KAWASAKI HYDRAULIC STEERING GEAR SERVICE NEWS

ISSUE : NOV, 11, 2025
DOC. NO. E8-25-001

Recommendation for Replacement of LVP017 Hydraulic Pump Complete Assembly

Figure 3: LV Series

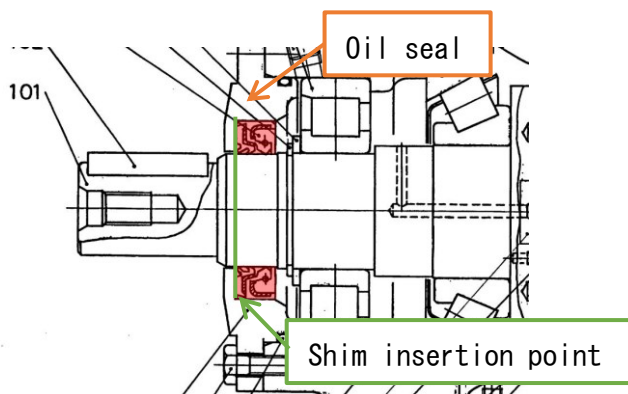
overhauling the LV series, the oil seal is replaced and, at the same time, a shim is inserted at the location indicated by the green line in Figure 3 to shift the contact position between the oil seal and the drive shaft. Due to the internal dimensions of the pump, this procedure can only be performed once. On the other hand, since there is no space to insert a shim in the LVP017, it is not possible to shift the position of the oil seal (see figure 4).

Figure 4: LVP017

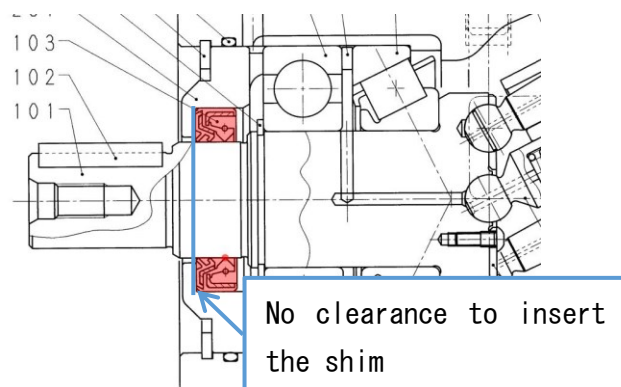
If the oil seal is replaced without being able to shift its position, the new oil seal will come into contact with the worn area of the shaft. As a result, even after performing an overhaul, there remains a significant risk of oil leakage.

For the reasons stated above, we recommend replacing the complete LVP017 assembly when overhauling the small size steering gear.
